**Re: DPIE Submissions for proposed Modification 2 of the Dunmore lakes Sand
Project – Email from Boral 14/08/2019**

DPIE and Shellharbour Council have provided submissions regarding the proposed Modification 2 of the Dunmore Lakes Sand Project. This submissions relate to water quality and flooding issues addressed in the Surface Water Assessment prepared by Southeast Engineering and Environmental. (Table 1).

Table 1 Summary of submission issues and response.

FIG 45. PMF flood hazard, existing conditions.

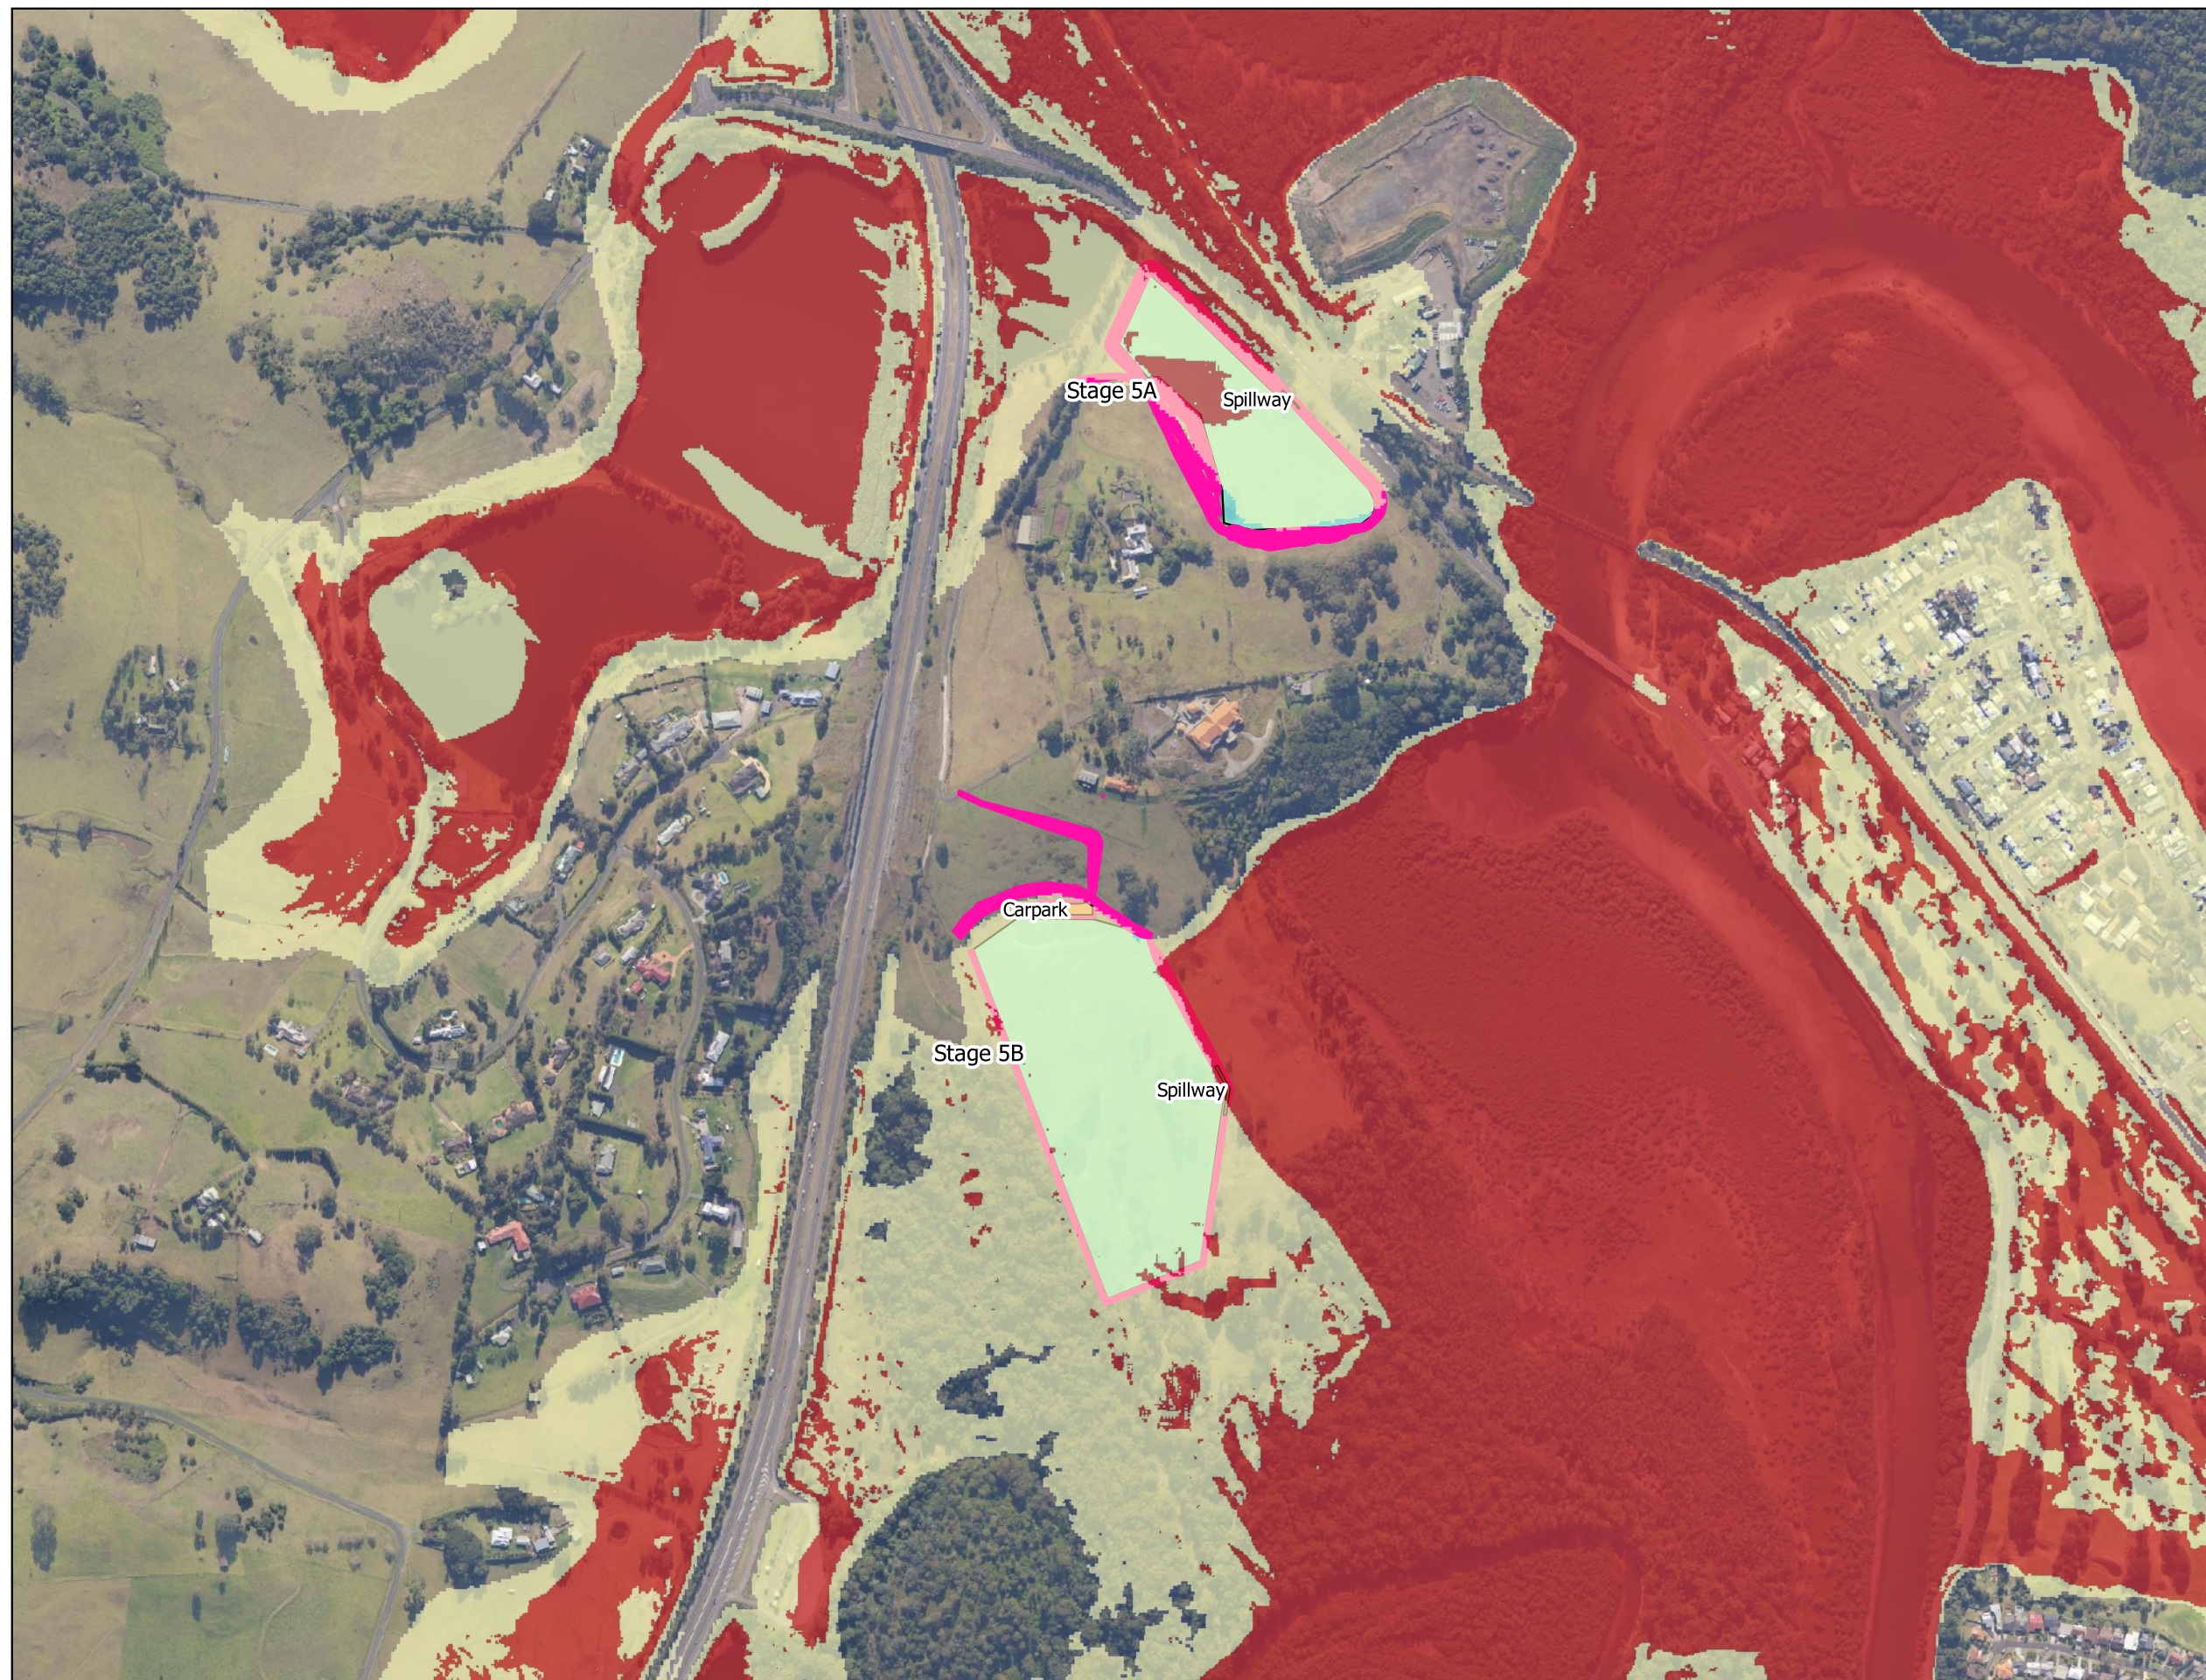
Shellharbour Council (Appendix 1, 09/08/19)	1. Hazard maps for the PMF missing.	Pre and post development maps for the PMF hazard attached (Fig 45 and 46).
